Delegated Report		Analysis sheet	Expiry Date:	31/10/2018
		N/A	Consultation Expiry Date:	06/11/2018
Officer		Application Number(s)		
Matthias Gentet		2018/3992/P		
Application Address		Drawing Numbers		
Flat 3 15 Kingdon Road London NW6 1PJ		Refers to draft decision notice		
PO 3/4	Area Team Signature	C&UD	Authorised Officer Signature	
Proposal(s)				
Roof extension including new hatch access, front and rear dormers and creation of a rear roof terrace with railings within lower second floor roof.				
Recommendation(s):	Non-determination – Council minded to refuse Planning Permission			
Application Type:	Full Planning Permission

1. Proposal and Background

- 1.1 Planning permission is sought for a roof extension including a new hatch access, new front and rear dormers and the creation of a rear roof terrace with railings within lower second floor roof.

Rear Dormer and Roof Terrace

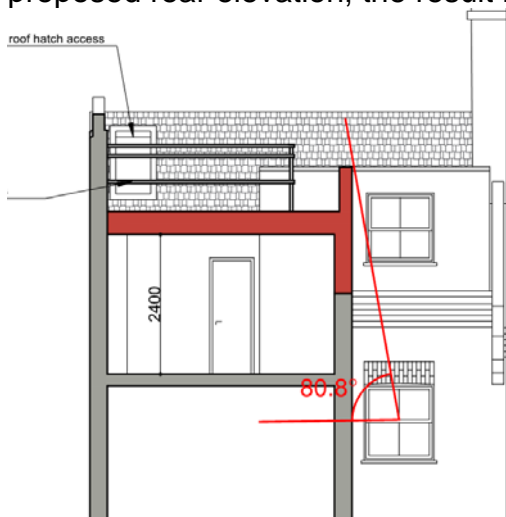
- 4.7 The proposed terrace and associated railings at third floor level on the roof of the two storey closet wing would not allow direct views into windows of any neighbouring flats. The distance between the proposed rear roof terrace and the rear windows at No19 Dennington Park Road is approximately 27m, at least 9m further than the requested 18m.
- 4.8 The enlargement of the rear dormer window would not create any further harmful overlooking into neighbouring properties than is already experienced from the existing rear dormer.
- 4.9 In terms of overlooking and privacy, the rear roof terrace and rear dormer are considered to be acceptable and in accordance with policy A1.

45° test from No17 rear dormer (approximate location)

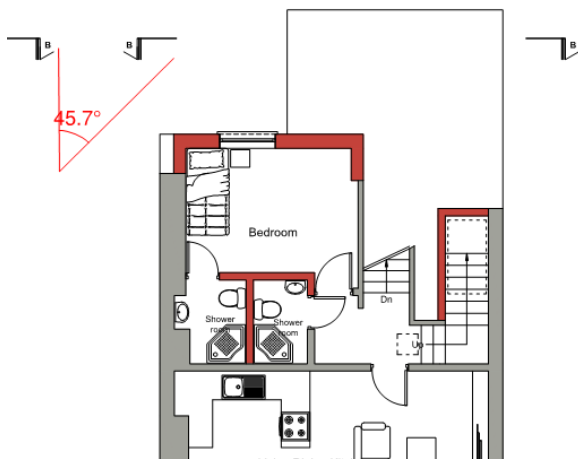
- 4.11 Applicants are expected to use the 45-degree test and the 25-degree tests to screen their proposals to determine whether a sunlight and daylight report is required. The screening procedure is set out in Figure 1 (CPG1 Design). The 45° test has been carried out on the proposed rear elevation, the result is as follows:

The desktop assessment shows that the proposal would not pass the 45 degree test in elevation and is in excess of the recommended 45° - at 80.8°. However it must be noted that the existing closet wing would also break the 45° line in elevation when taken from the second floor window of the flat below. The proposed alterations to the closet wing roof form would not be considered to result in further loss of light to the flat below and would be considered acceptable.

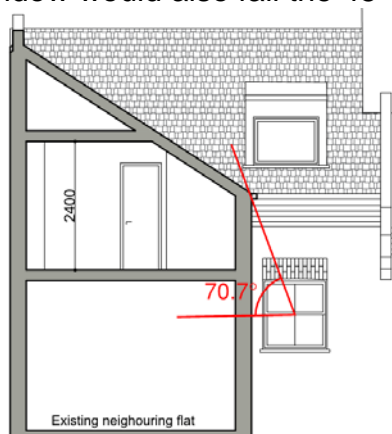
4.12 It is worth noting that the current proximity of the closet wing to the same rear 1st floor window would also fail the 45° test, as shown on the below shot:

At 70.7°, the existing closet wing is impacting on the level of natural light entering the below flat through the rear 1st floor window. This part of the proposal would therefore exacerbate the current issue with the loss of natural light.
